PLANNING APPLICATION ATTACHMENT A Proposal

Description of proposal: NEW DWELLING & SHED

Site address: 637 RELBIA ROAD

Planning Application P15-298 - Information Required
Dwelling & 6 bay two storey shed (8 x 24m, apex 8.55m) at 637 Relbia Road, Relbia

DRAWING No
A01

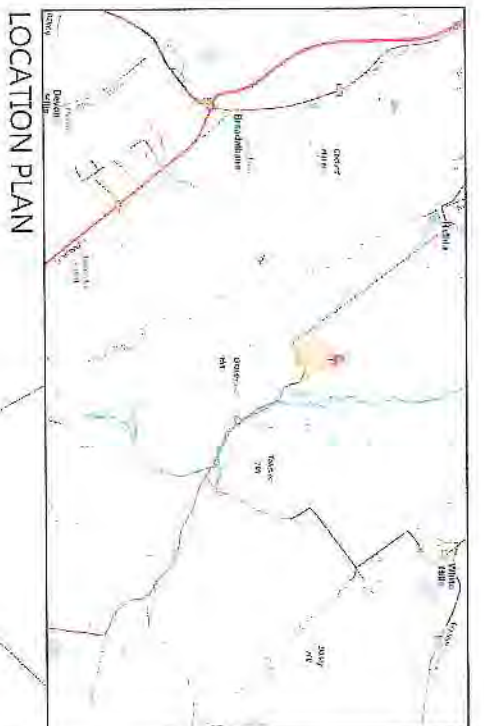
- **Corrected plans**
The site plan and floor plans for the shed do not match. Please provide corrected plans, including a dimensioned floor plan of the shed.

It is noted that the shipping containers, approved under P14-048 are located on site. Please ensure that these shipping containers, in addition to any other existing buildings on site, are shown on the site plan.

- **CORRECTED PLANS** Please also find attached the amended site plan stating correct size of shed and dimensions of shed.
- **COST OF CONSTRUCTION** As stated to you it was our intention to finalise the amount once receiving our quotes. Though you have a much larger figure for cost of construction, myself and my son will be very involved in this build. We already have a bank pre-approval and we expect the build to not exceed \$550,000. Just let us know if you want us to pay that excess on the \$250,000.

Here is the amended plan and the planning report showing the staging of the development with timelines explained in the report. Other than fees I think this covers the RFI – don't know about the fees.

DRAWING No: A07

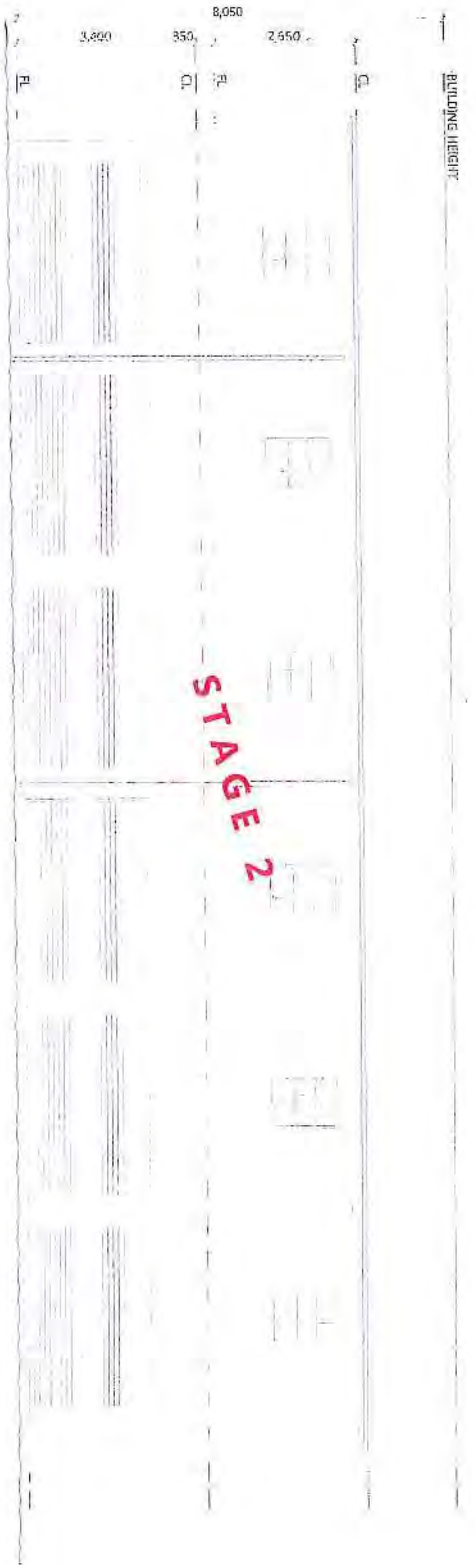
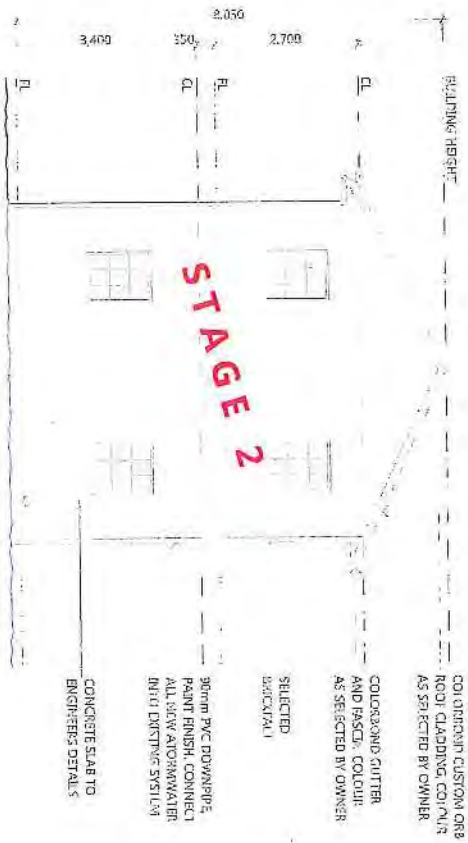
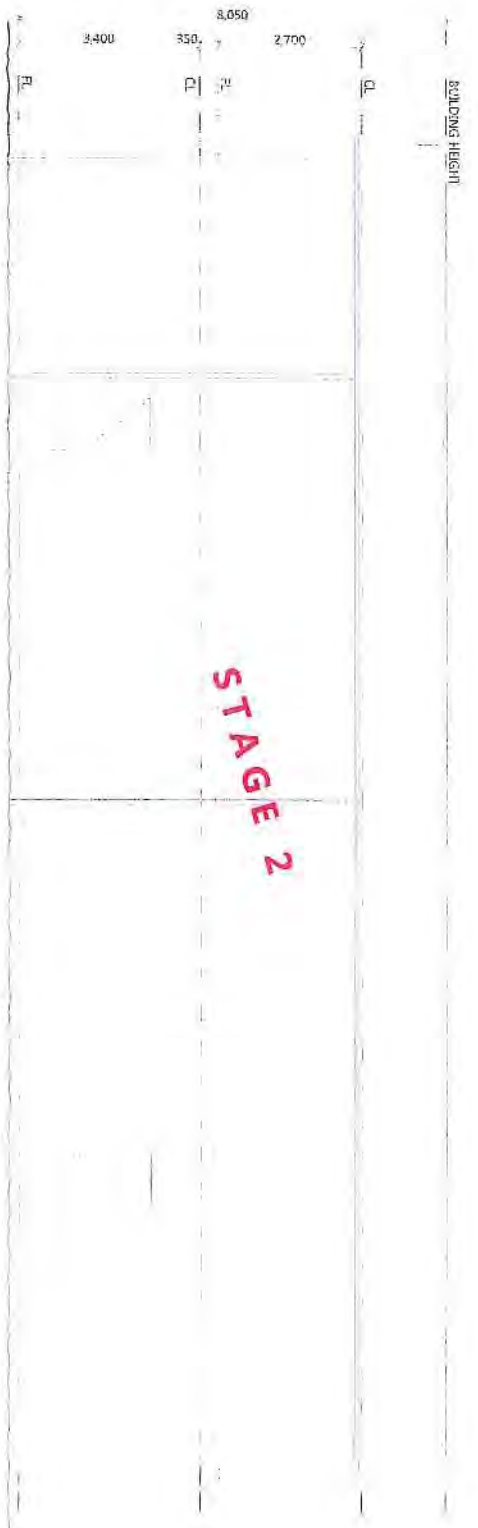
Our first comment relates to the new shed. A 24m, two-storey shed, in that location, only 19.5m from our boundary, would be obtrusive and oppressive. We feel it would have an adverse, visual impact on us, as neighbours, as it would present as a very high, solid brick wall (D.S. p1 b). In no way would it "complement the character of the surrounding landscape" (D.S. p1 a).

The application is for a 24 metre 2-storey shed to constructed closer than the permitted distance to the southern side boundary. This will adversely impact on the adjoining property and has potential to devalue the property due to the reduced privacy . As a Real Estate professional it would be my view that the motivation for people to live on small holdings in Rural areas is to enjoy privacy and separation from the activities of their neighbours. It is primarily for this reason that setback distances are in the planning scheme and it is not appropriate to vary them in this instance , particularly given the size and height of the proposed "shed".

In response to comment one (regarding the shed) can we say that there are many large brick sheds from the Georgian period that are very attractive to the eye and fit into the landscape of Tasmania very well. There are also many sheds in Tasmania, in rural settings, that are this size and even larger. Our town planner that we engaged had informed us that under the Rural Resource zone we could go to a height of 12m if necessary. There may be some discrepancy to that but it is true that you can have sheds in rural areas up to 12m and we would claim compliance in regard to height. We do live in a rural area and it is our intention to make the majority of this shed for rural purposes. In regards to (an adverse visual impact) we find that very hard to understand. These comments which come from our direct neighbour who has no direct vision from their house to the said shed. It is true, as they walk down to their back shed along our boundary, that they will be able to see through a section and see the shed but that does not make it unacceptable in its location. May I also say that a condition of an existing approval that we have on this property, was to plant a buffer area along the boundary of this neighbour and those trees have been planted and once established there will be absolutely no line of sight of this shed from their dwelling/shed area. Can we note that it is only 5cm above the 8m allowance. The scheme does not say that you cannot have above this height but as it was an already built historical shed, recovered from the Rosebury Catholic School, and that was its original height, we are therefore seeking Council's permission to gain that extra height, which will be unrecognisable to the eye. As with the dwelling which is also asking for approval for above 8m, as stated in the report, with a distance of 180m from the road, this extra height will not be noticed considering also that the land is lower than the road, therefore not seeming to be obtrusive. It is to be also noted that there are very few positions from Relbia Road that you can sight this area, the reason being that the positioning of other neighbours trees and the Hawthorn Hedge makes seeing through very difficult. Can we finish in answering this point in saying that it would be unfair to say that Georgian type buildings have an adverse visual impact and do not compliment the character of the surrounding landscape. We would argue that in Tasmania especially, they enhance the surrounding landscape.
